SUNDRY NOTICES AND REPORTS ON WELLS

OXY USA Inc. - Proposed
C.E. LaMunyon Federal #10
API No. 30-025-10830

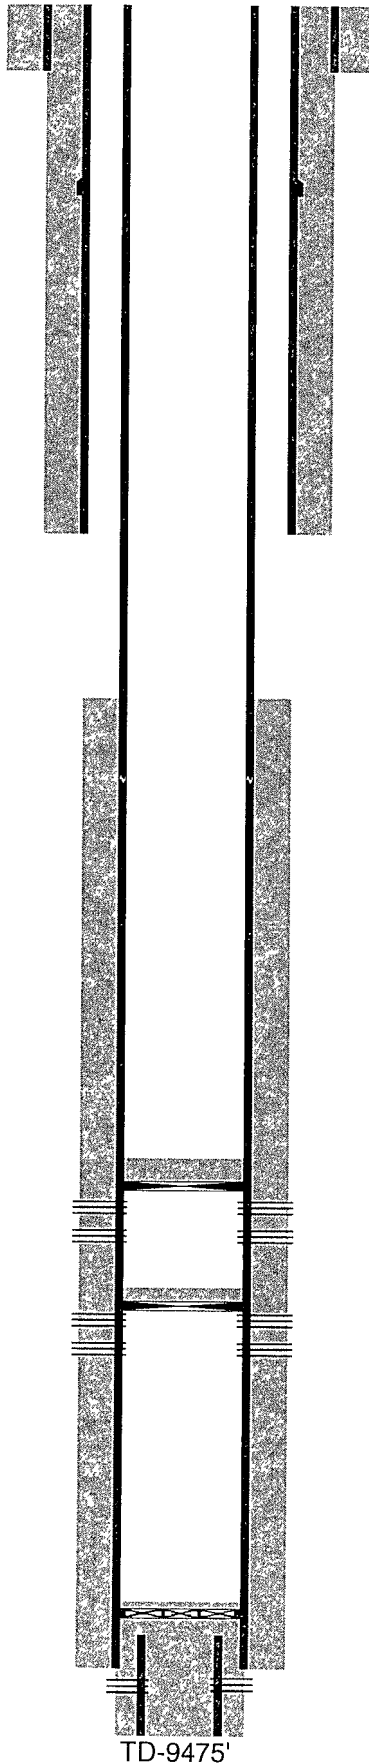
C.E. LaMunyon Fed. #10. CIBP @7273' needs more cement on top add 25 sacks prior to setting next CIBP @6525'. Well may be approved to be TA/SI for a period of 90 days until October 1, 2011 after successful MIT and subsequent report with well bore diagram is submitted. This will be the only TA approval for this well. Well must be P&A or plans to return to beneficial use submitted by October 1, 2011. Well was drilled 5/1949. Well was SI 5/2009.
